Land at Dan y Graig

Planning Statement Appendix 2024

Re: Land at Dan y Graig Pontwalby

I write with regard to the above Outline (all matters reserved) proposal for 3 dwellings.

Approved Historic Plan – regarding the water trunk main location – for information.
 Nore red line forms same line at access. Minor difference in red line at eastern end due to flood zone extent. Blue line differs due to the Sale of the house and land east of Nant Gwrelych..

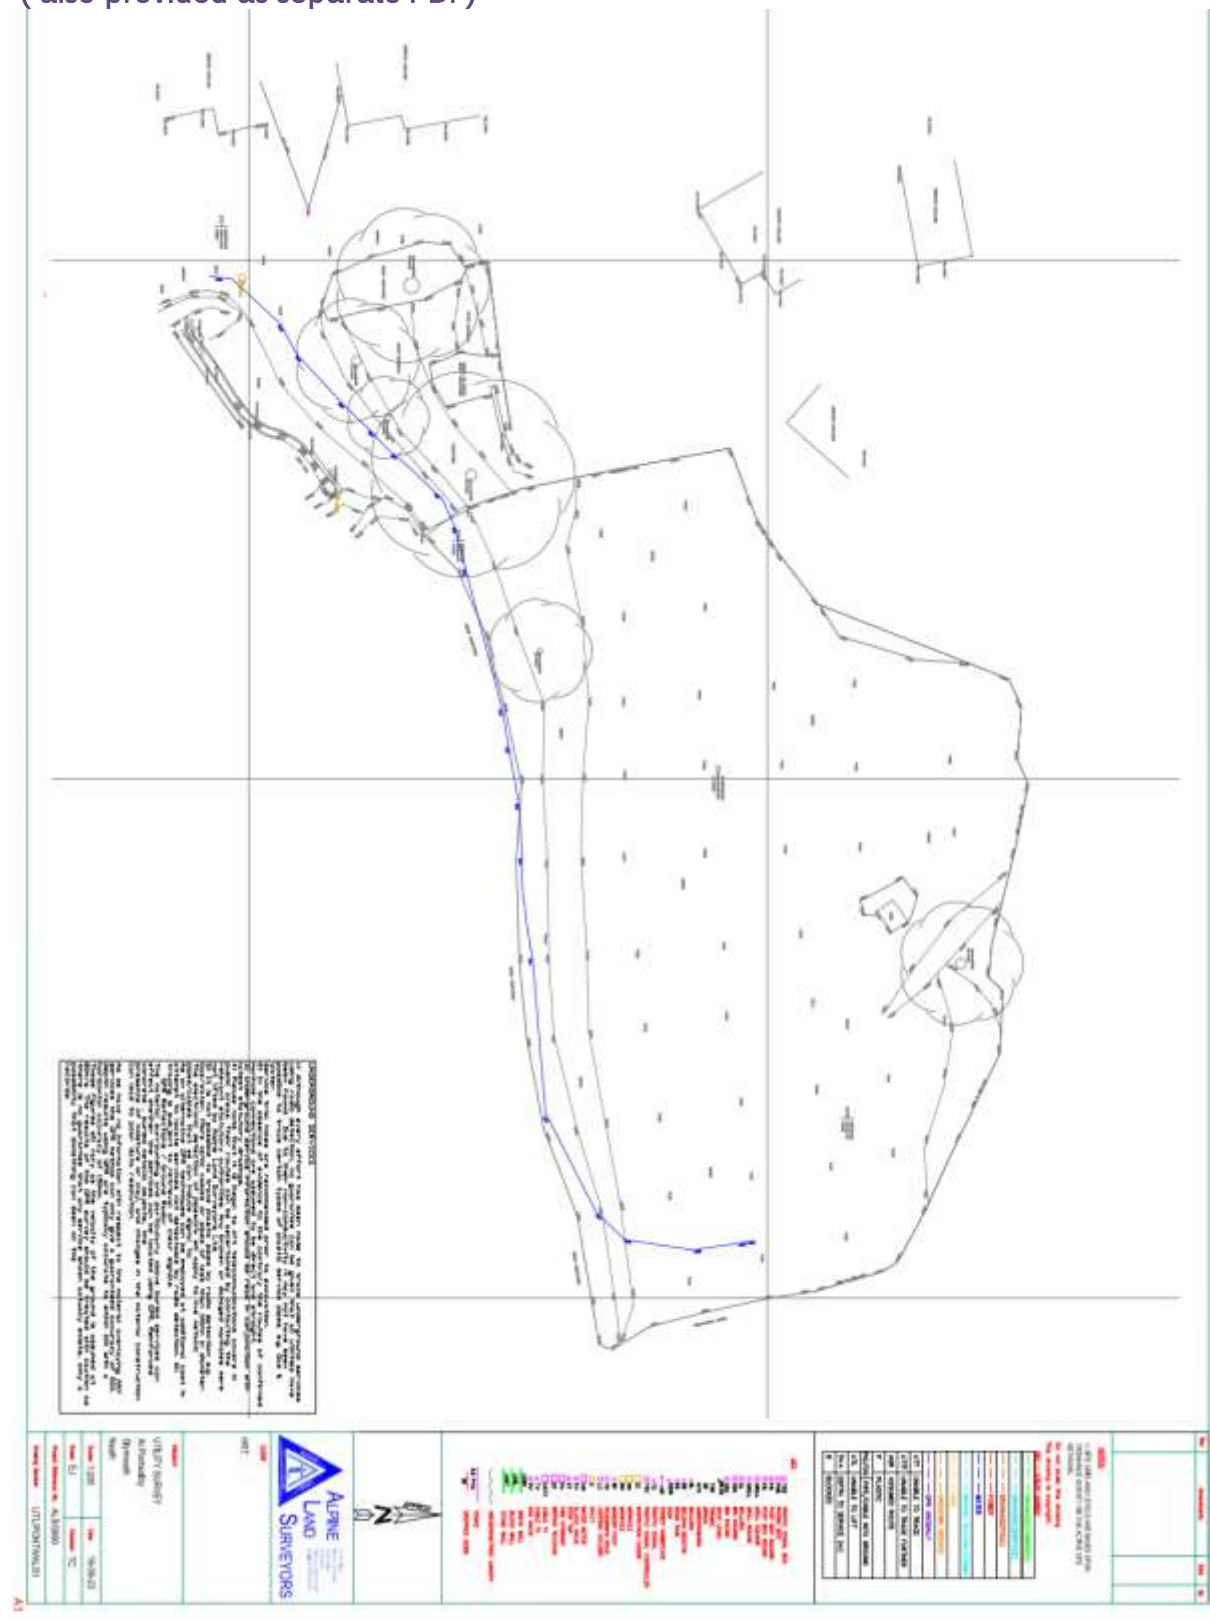
The proposed development is crossed by a trunk/distribution watermain, the approximate position being shown on the attached plan. Under the Water Industry Act 1991 Dwr Cymru Welsh Water has rights of access to its apparatus at all times. I enclose our Conditions for Development near Water mains. It may be possible for this watermain to be diverted under Section 185 of the Water Industry Act 1991, the cost of which will be re-charged to the Developer.

Screen shot, close up of Section A shown on the attached [plan](#)

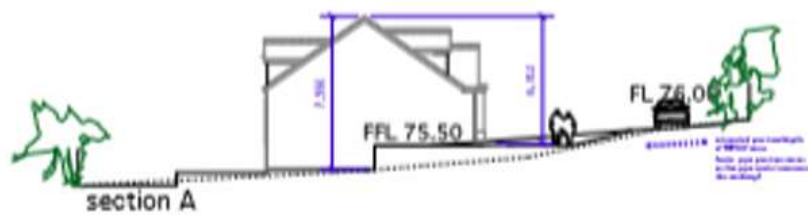
I have reviewed these details with Andrew and in it's current state we would not be able to accept the proposals and the watermain would require diverting. From looking at the cross-section drawings that have been supplied and paying particular attention to cross section A, the watermain will either be above the finished road level or have insufficient cover. There is also a concern where the main runs adjacent to the edge of the carriageway. The main is likely to be above the finished road level in the embankment where the lateral stability of the main will have been compromised and risk of the main slipping.

Also, to add to my below email, from reviewing the cross sections the proposals appear to show the existing levels around the water main being reduced by a depth ranging from 1.9m to 2.5m.

DCWW: I have reviewed these details with Andrew and in it's current state we would not be able to accept the proposals and the watermain would require diverting.

DCWW: From looking at the cross-section drawings that have been supplied and paying particular attention to cross section A, the watermain will either be above the finished road level or have insufficient cover.

DCWW: There is also a concern where the main runs adjacent to the edge of the carriageway. The main is likely to be above the finished road level in the embankment where the lateral stability of the main will have been compromised and risk of the main slipping.

DCWW: From reviewing the cross sections the proposals appear to show the existing levels around the water main being reduced by a depth ranging from 1.9m to 2.5m.

As you discussed we are not seeking to divert the main, we are seeking to amend the scheme in order to protect and accommodate the main. As you are aware the main sits under the road and within the mouth of the existing access - this access is used for turning on a regular basis at the top end of Glen Gwrelych.

We were advised prior and in our meeting that DCWW are not aware of the depth of the main and this is why trial holes were requested from the applicant in order to establish the depth of your asset. From the comment above it appears there is knowledge as to the depth of the main. If you have any information we would be grateful for you to share this to inform the process.

For the moment the architect has assumed a depth of the main as shown on the plan (in line with standard depth range). We have ensured the ground cover for the main is neither increased or decreased by bringing the parking areas for the cars at grade with the road. The road continues from the hard surfacing that currently sits from Glan Gwrelych up to the position of the gate (see attached photo for clarity).

In the revised plan the main will therefore not be above the finished road level or have insufficient cover.

The DCWW main crosses the access road at Section A and then sits to the left hand side of the road. The pipe crosses from left to right and this is shown (at an estimated depth) on the attached plan.

In the amended plan the existing levels are left in situ around the main, the main will therefore be protected by the existing ground cover - this is demonstrated in Sections A, B and C on the attached plan. I attach a close up screenshot of Section A below for your reference. Note the thin back line behind the people is the front garden. The people are standing on the driveway in front of the house (no vehicle is shown parked on Section A but see Section B and C for how the vehicle would be parked).
